# STEPHENSON HIGH SCHOOL

## City of Dripping Springs VE Budget Summary

September 3, 2024

*Rehabilitation of the Historic Stephenson  
High School Building and Addition*

## West Elevation

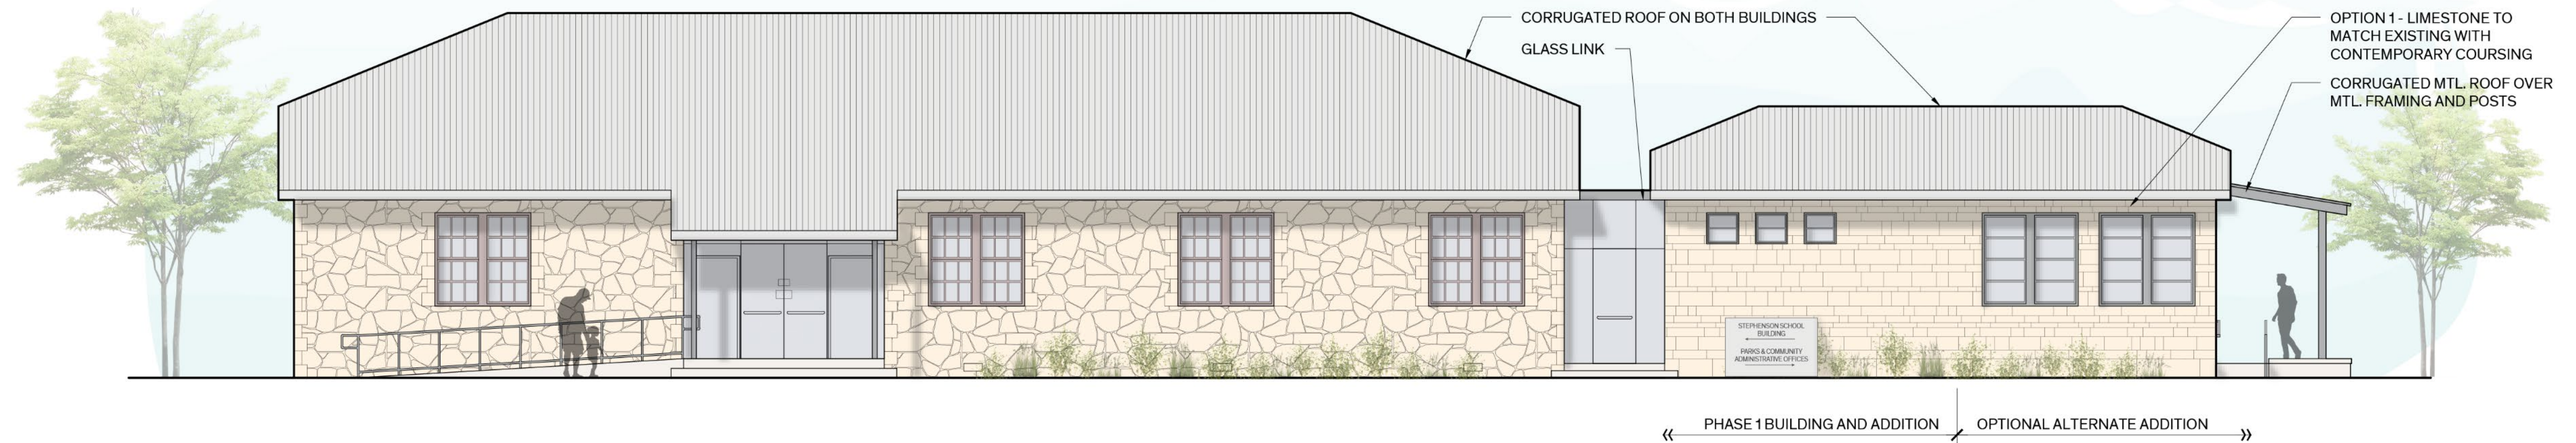
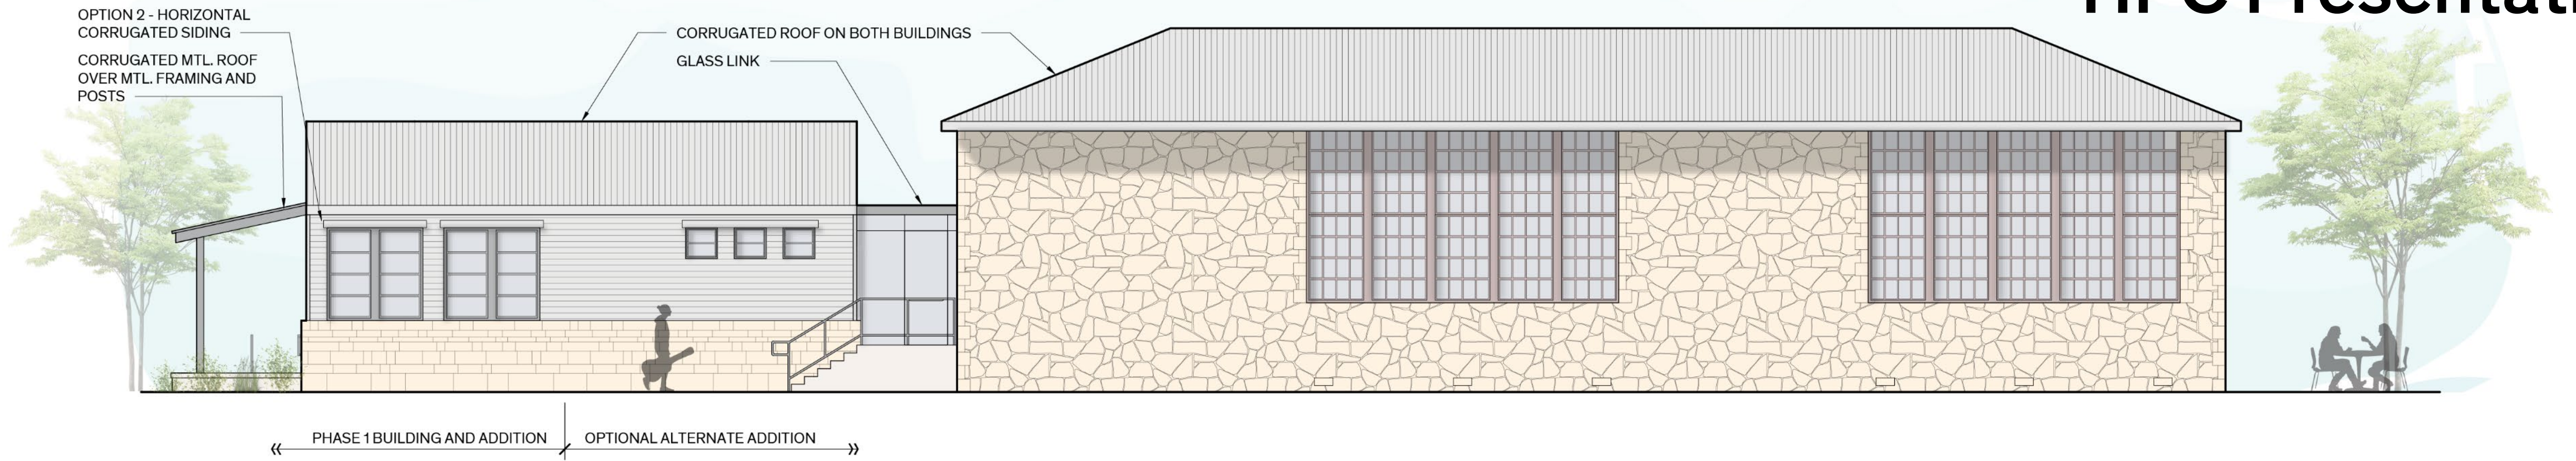
DESIGN CHANGE	A32	FULL LIMESTONE FAÇADE	LIMESTONE WAINSCOT WITH CORRUGATED METAL	\$	53,659.60	
DESIGN CHANGE	A11, A35, D1	EAST PORCH	REMOVE EAST PORCH, INSET VESTIBULE ENTRY	\$	15,000.00	
				% ACHIEVED		
<b>TOTAL SAVINGS</b>				<b>\$</b>	<b>220,010.57</b>	<b>7.42%</b>
	B32	AV EQUIPMENT ALLOWANCE	OFOI	\$	50,000.00	
	B32	STAGE LIGHT BAR ALLOWANCE	OFOI	\$	10,000.00	
<b>OWNER FURNISHED OWNER INSTALL COST (OFOI)</b>				<b>\$</b>	<b>60,000.00</b>	<b>2.02%</b>

# Limestone Wainscot with Corrugated Metal HPC Presentation
